## **NORTHERN BEACHES LOCAL PLANNING PANEL MEETING**

**WEDNESDAY 18 SEPTEMBER 2019**

**ITEM 3.1** MOD2019/0312 - 0 SANDY BAY ROAD, CLONTARF -  
MODIFICATION OF DEVELOPMENT CONSENT DA91/2015  
GRANTED FOR ALTERATIONS AND ADDITIONS TO AN  
EXISTING CAFE

**C. Delete Condition 27A which reads as follows:**

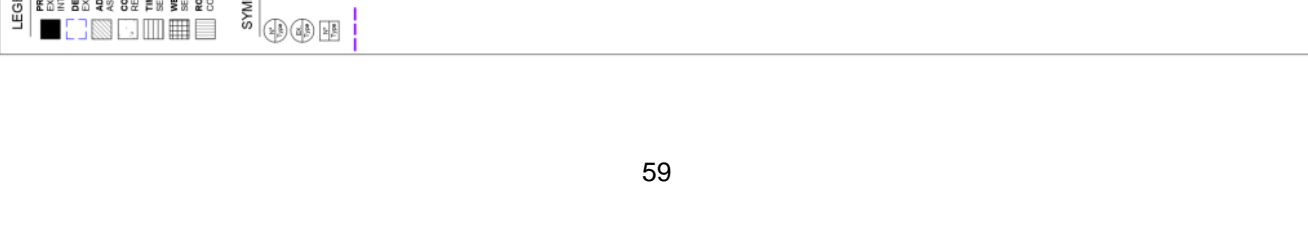
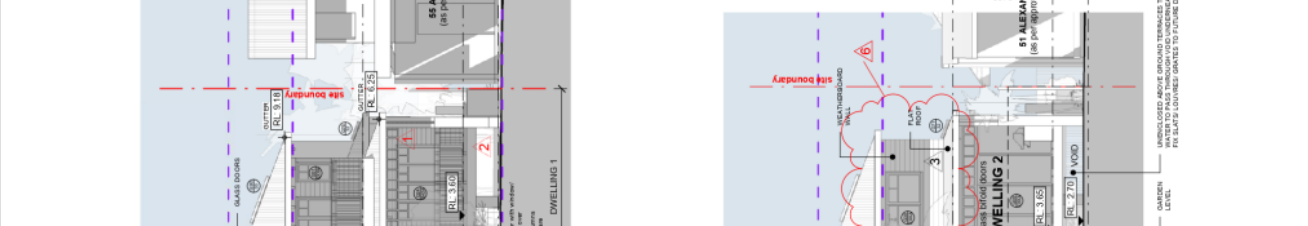
The underfloor area of the dwelling and perimeter of the dwelling below the 1% AEP flood level of 3.15m AHD are to be designed and constructed to allow clear passage of floodwaters. The open walls

of the garage below the 1% AEP flood level are to remain open to allow clear passage of floodwater.  
The garage door must have a minimum of 50% open area below the 1% AEP flood level of 3.15m AHD.

### Further amended plans

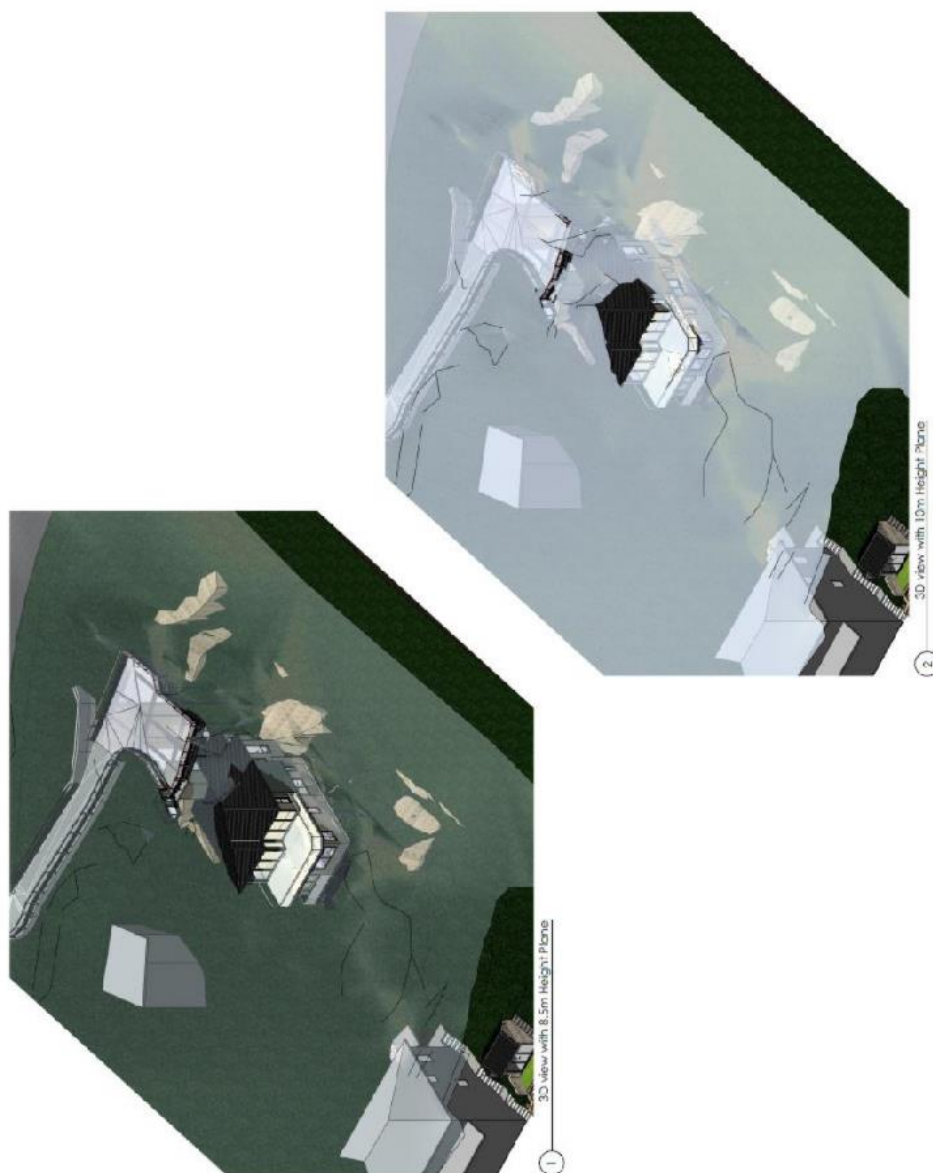
The main changes to the proposed dwelling house are that the two main levels have been moved 3.5m further towards the street and raised 3.295m. Insofar as building height is concerned, the maximum height above existing ground level is **12.3m** for the dwelling house itself and **11.5m** for the parking area. (It should be noted that the lift has been moved 165mm closer to the street to locate it further under the parking platform; the reason for so doing is to reduce building height. This notwithstanding the lift marginally exceeds the height control by some 100mm.)
